**Turtle Creek No. 3 Primary Pump Station Project**  
**Solicitation Number: CO-00404-SM**  
**Job No.: 21-6001**

**ADDENDUM NO. 4**  
**September 21, 2021**

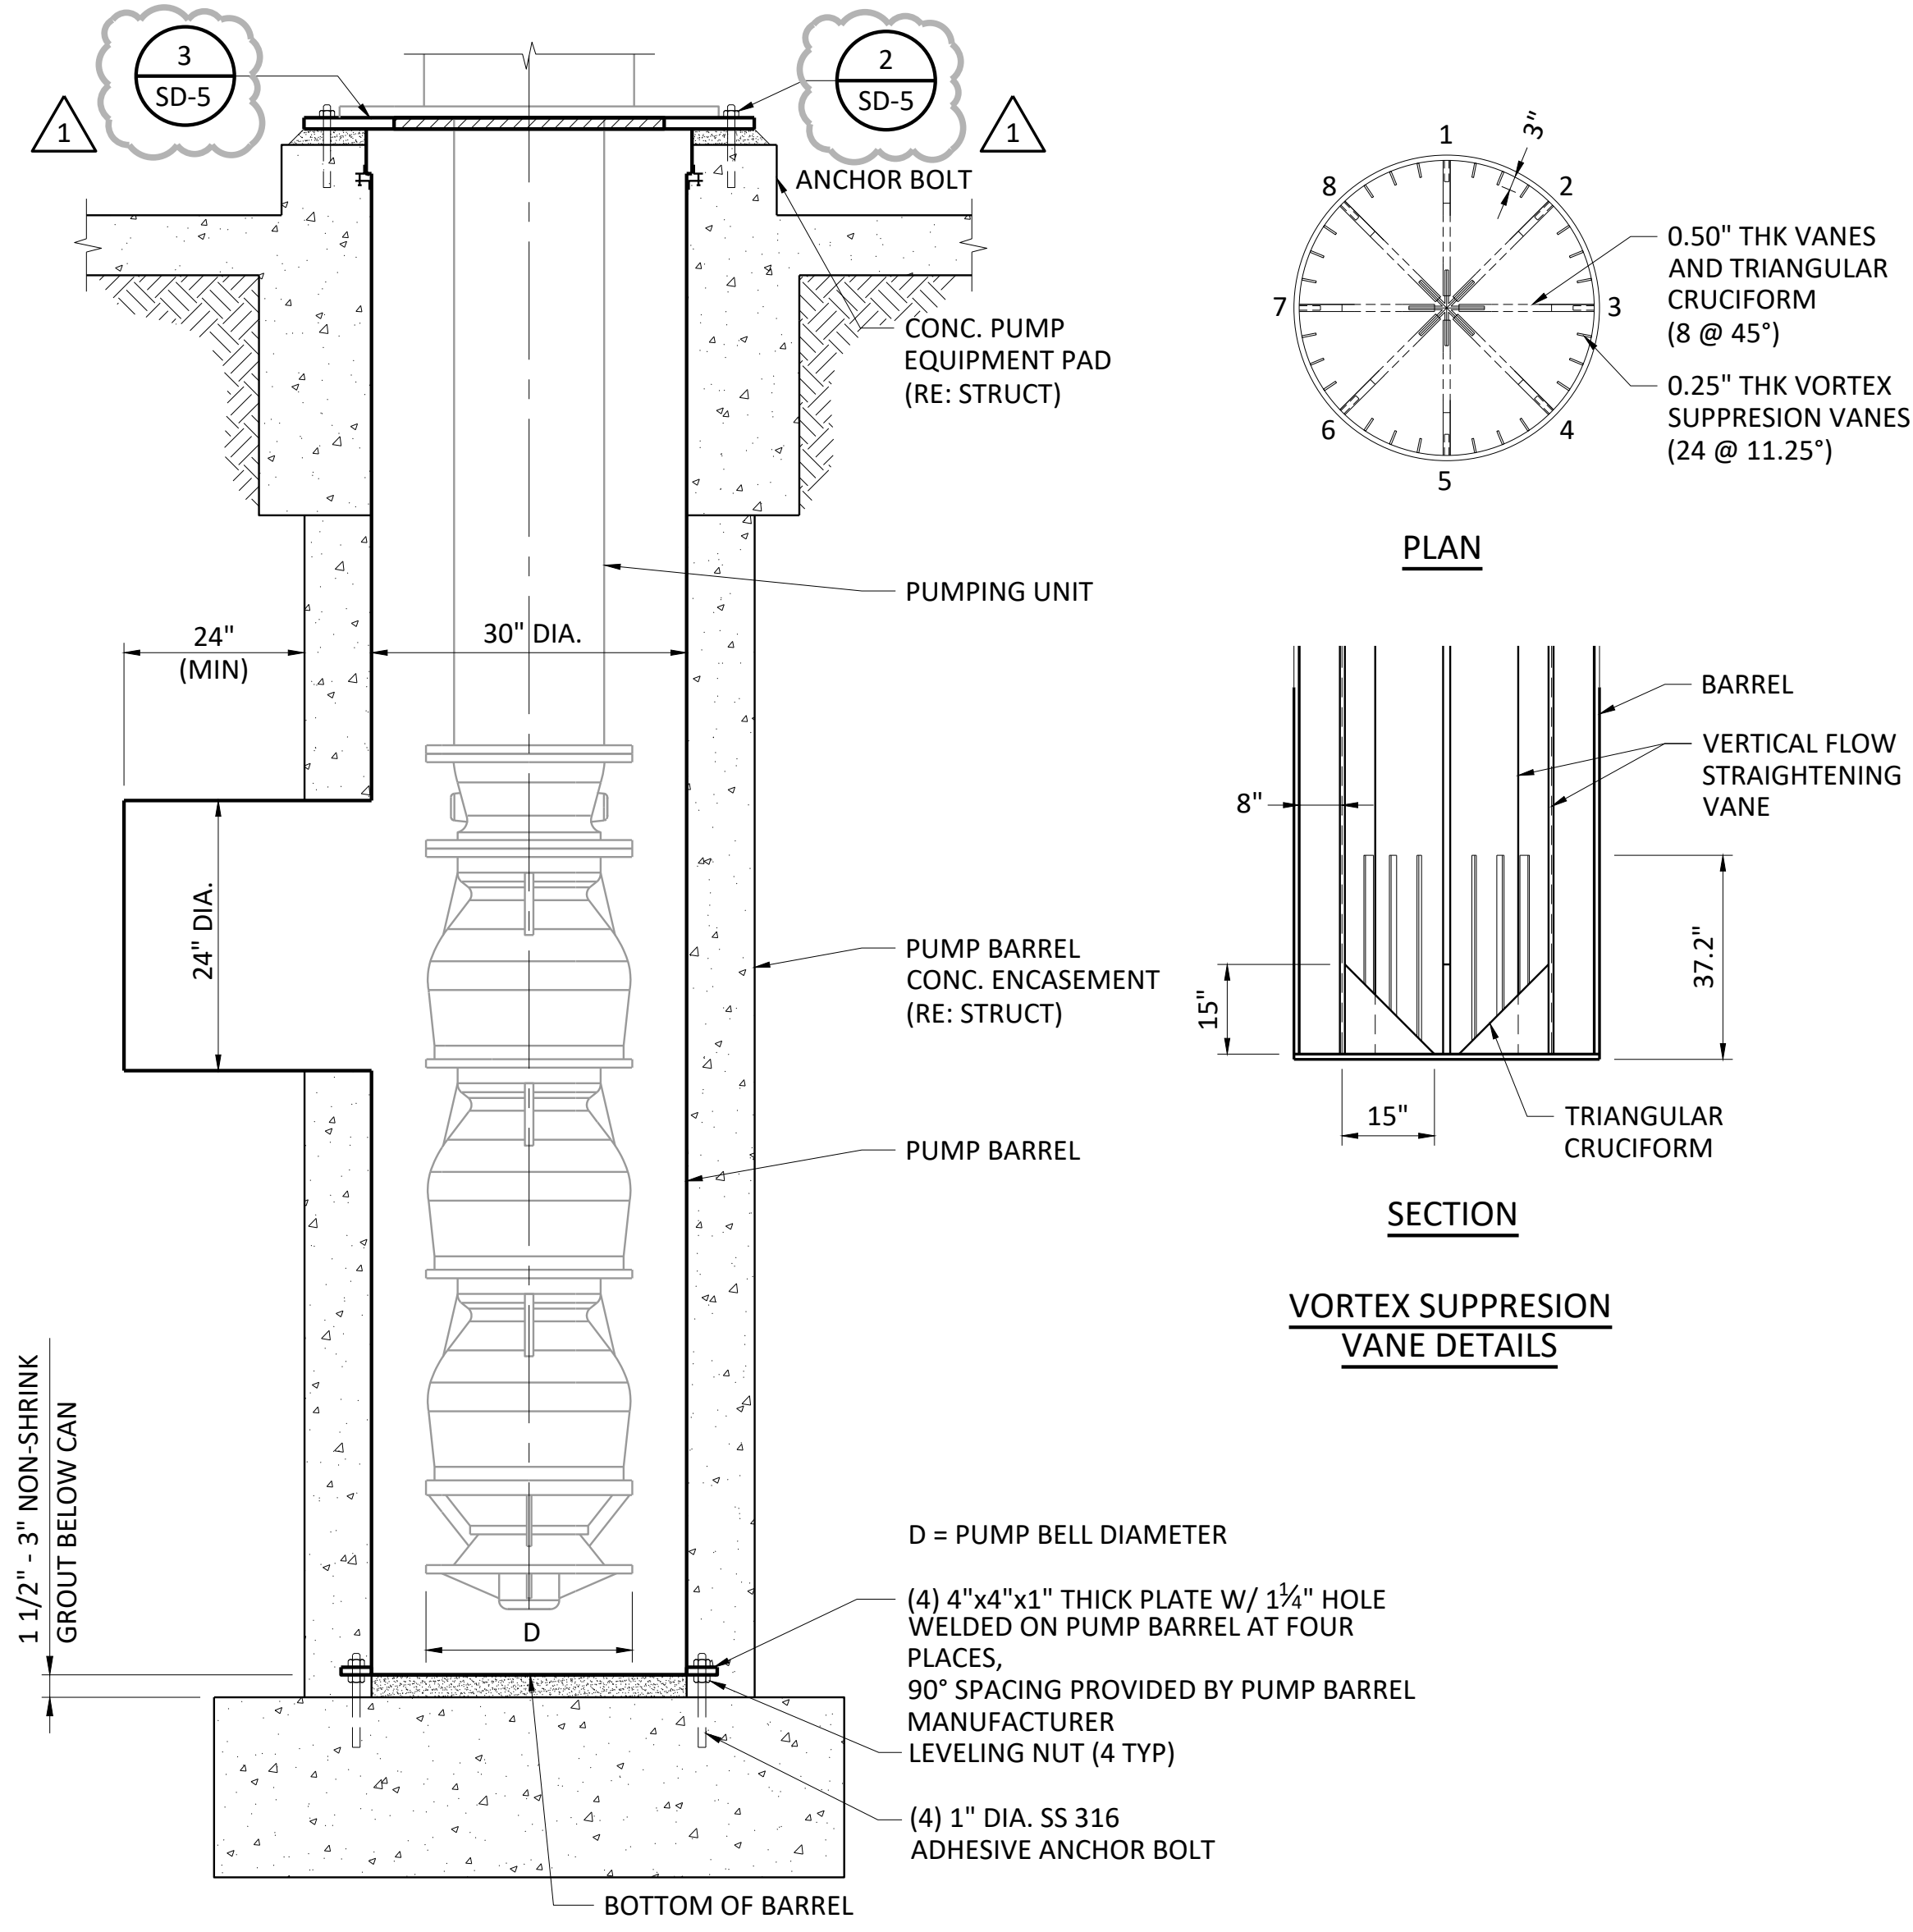
1. **Delete** Drawing G-5 in its entirety **and replace with** revised Drawing G-5 included in this addendum.
2. **Delete** Drawing SD-5 in its entirety **and replace with** revised Drawing SD-5 included in this addendum.
3. **Delete** Drawing SD-6 in its entirety **and replace with** revised Drawing SD-6 included in this addendum.
4. **Delete** Drawing S-1 in its entirety **and replace with** revised Drawing S-1 included in this addendum.
5. **Delete** Drawing E-4 in its entirety **and replace with** revised Drawing E-4 included in this addendum.
6. **Delete** Drawing E-8 in its entirety **and replace with** revised Drawing E-8 included in this addendum.
7. **Delete** Drawing EB-7 in its entirety **and replace with** revised Drawing EB-7 included in this addendum.
8. **Drawing T-4, Note 2:**
